MECKLENBURG COUNTY
DEPARTMENT OF ENVIRONMENTAL HEALTH

SITE EVALUATION

S.I.R. NO. 20318

Re: Property located at Overbrook Terrace, Lot #1

**See Diagram on Back (includes: soil areas, property lines, roads, streams, gullies, wet areas, fill areas, wells, water bodies, slopes)

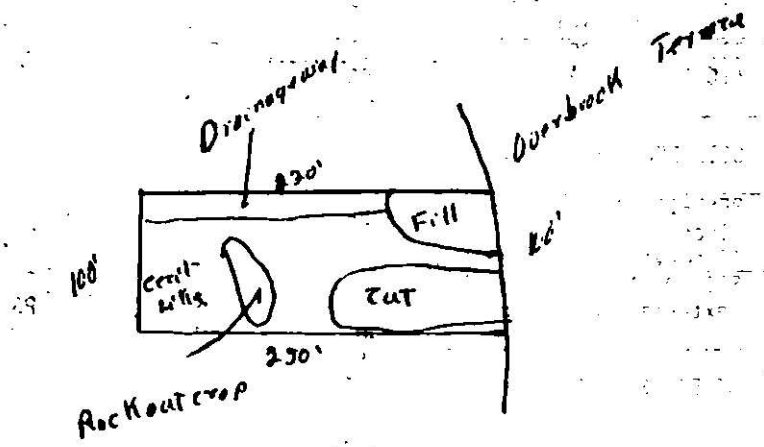
FACTORS	AREA 1	AREA 2	AREA 3	AREA 4
1. SLOPE (%)	S / PS 8-20% / U	S / PS complex slopes / U	S / PS 2-8% / U	S / PS 2-8 / U
2. SOIL TEXTURE (12-36 inches) Sandy, Loamy, Clayey (Note 2-1 Clay)	S / PS clay / U	S / PS — / U	S / PS clay / U	S / PS — / U

3. SOIL STRUCTURE (12-36 inches)	S / PS Blocky / U	S / PS — / U	S / PS Blocky / U	S / PS — / U
4. SOIL DEPTH (inches)	S / PS 30-40" / U	S / PS — / U	S / PS <30" cut / U	S / PS — / U

5. RESTRICTIVE HORIZONS (Inches) (Impervious strata, Rock)	S / PS >30" / U	S / PS — / U	S / PS saprolite 0-18" / U	S / PS Fill compacted / U
6. SOIL DRAINAGE/GROUNDWATER (external and internal)	S / PS >30" to ground water / U	S / PS Drainageway & stream / U	S / PS >30" to ground water / U	S / PS — / U

7. OTHER (Specify)	S / PS Restricted Area / U	S / PS / U	S / PS / U	S / PS — / U
8. SOIL GROUP	12A	—	10A	—
9. SITE CLASSIFICATION	Unsuitable	unsuitable	unsuitable	unsuitable

10. SOIL SERIES	Cecil Lite	Drainage way	cut	Fill

Drainage way
Overbrook Terrace
230'
Fill
100'
Cut
250'
Rock outcrop
